NORTHEAST UTILITIES

Millstone Nuclear Power Station, Unit No. 3
Submittal of Draft Standard Technical Specifications

Northeast Nuclear Energy Company (NNECO) hereby submits draft Standard Technical Specifications (STS) for:

1. Three loop operation of Millstone Unit No. 3.
2. Revised draft STS to reflect ANSI N510-1980.
3. Revised draft STS that provide additional information not included in the original submittal.

FIGURE B3/4 2-1^a TYPICAL INDICATED AXIAL FLUX DIFFERENCE VERSUS THERMAL POWER

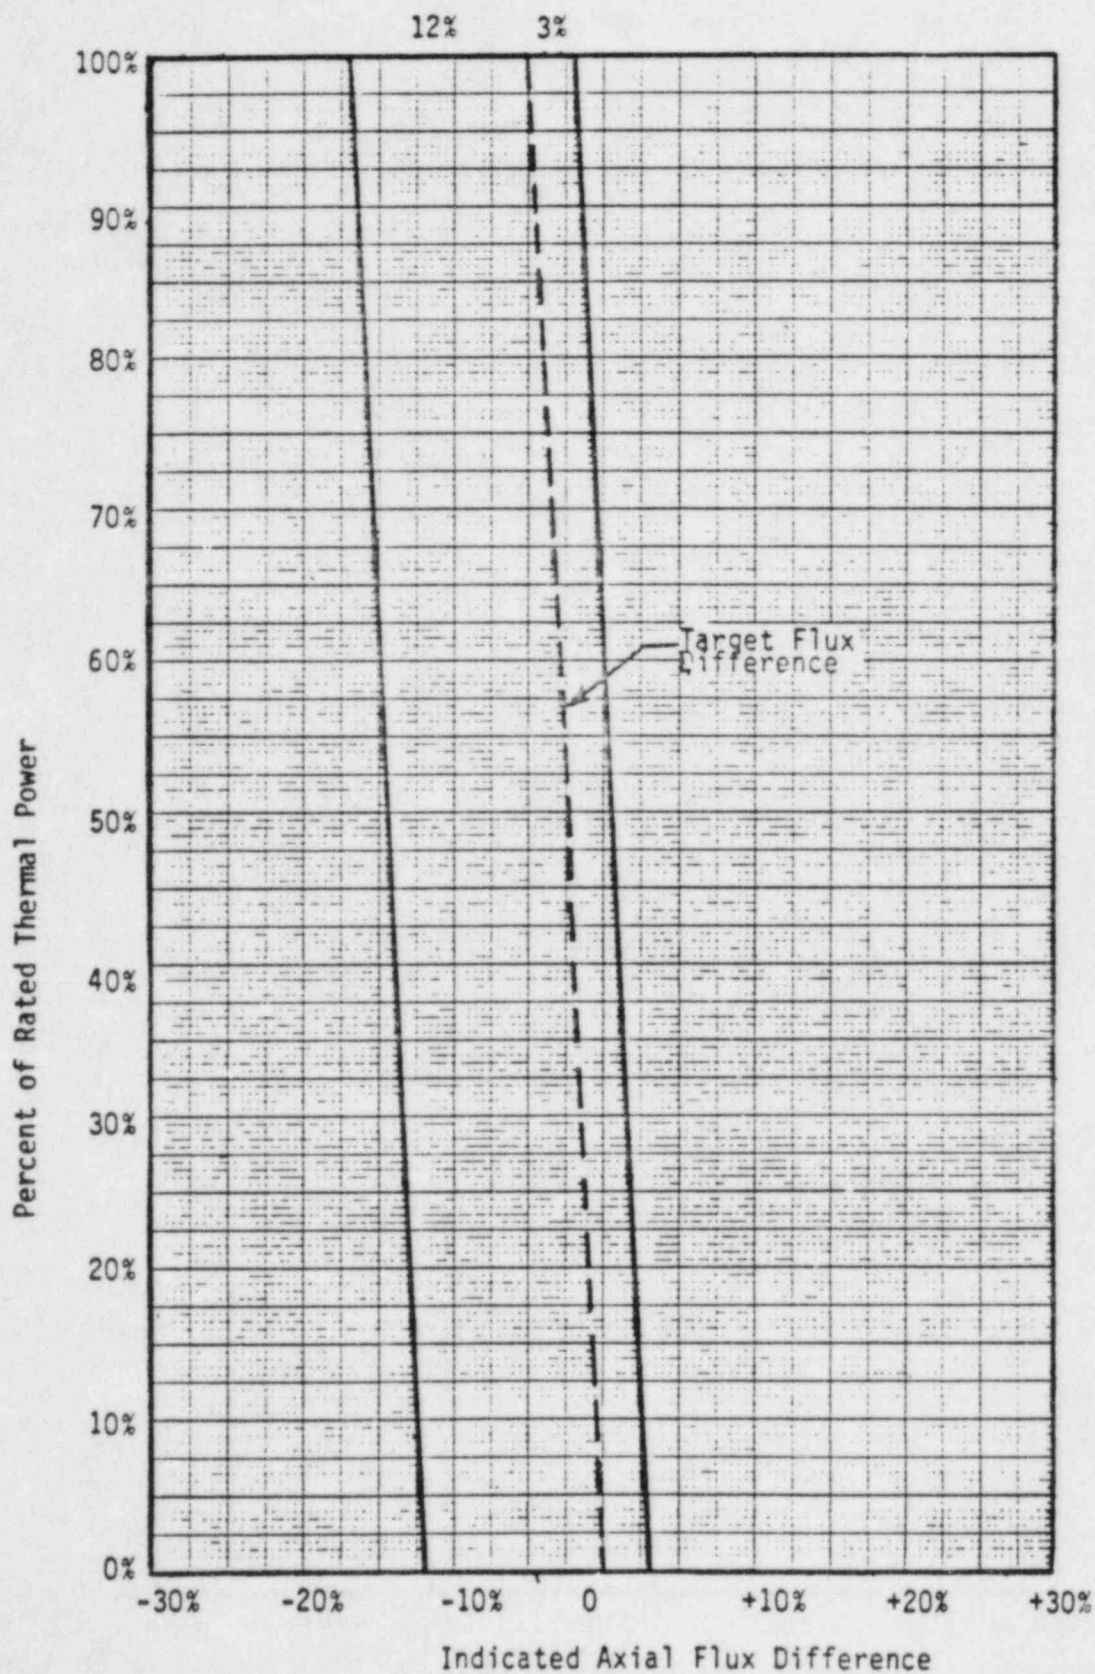
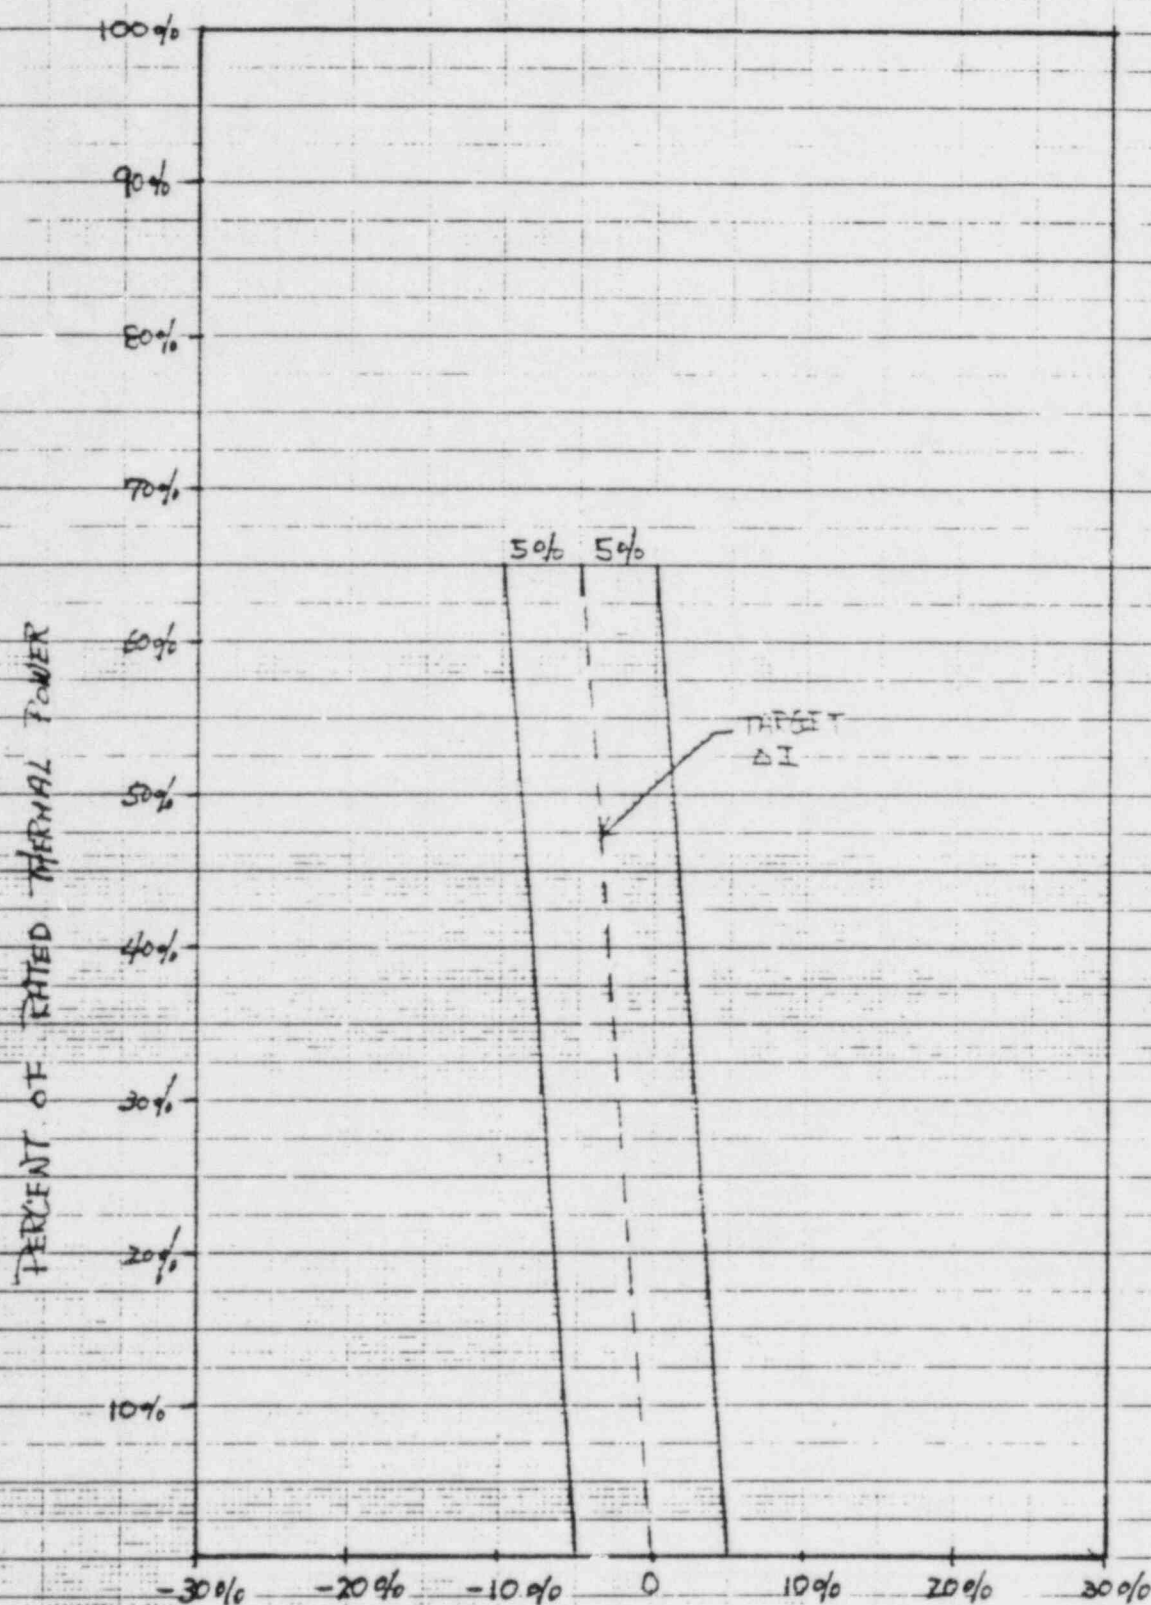
... but within the limits of Figure 3.2-12 and 3.2-16 while at THERMAL POWER levels between 50% and 90% of RATED THERMAL POWER (four loops operating) or between 32% and 65% of RATED THERMAL POWER (three loops operating). For THERMAL POWER levels between 15% and 50% of RATED THERMAL POWER (four loops operating) or between 15% and 32% of RATED THERMAL POWER (three loops operating), ...

During three loop operation at THERMAL POWER levels between 32% and 65% and between 15% and 32% RATED THERMAL POWER, the computer outputs an alarm message when the penalty deviation accumulates beyond the limits of 1 hour and 2 hours, respectively.
